From: John Carr <jcarrpdx@gmail.com>
Sent: Wednesday, February 28, 2018 11:34 AM
To: Ballew, Cassie
Cc: board (board@southtabor.org); Heron, Tim
Subject: LU 17-144195 DZ - STNA Response to New Evidence
Attachments: STNA-Response-Additional.pdf

South Tabor Neighborhood Association

RE: LU 17-144195 DZ

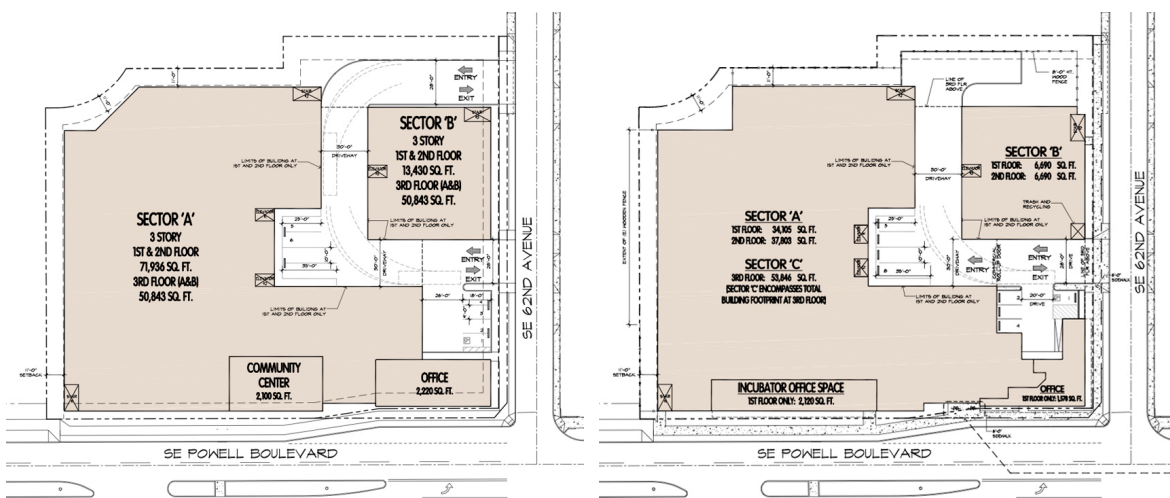
This is important to emphasize, as the applicant writes they have made efforts since the hearing to address concerns "without changing the building footprint" (Exhibit H.33, p. 1). This has been a guiding principle for them throughout the process. In fact, their latest proposal (Scheme A) has essentially the same footprint as the one originally proposed in March 2017:

(Notice too that the garage entries are even in the same inappropriate places as in the initial proposal, even though the U-shaped driveway pattern that necessitated that placement was abandoned in July.)
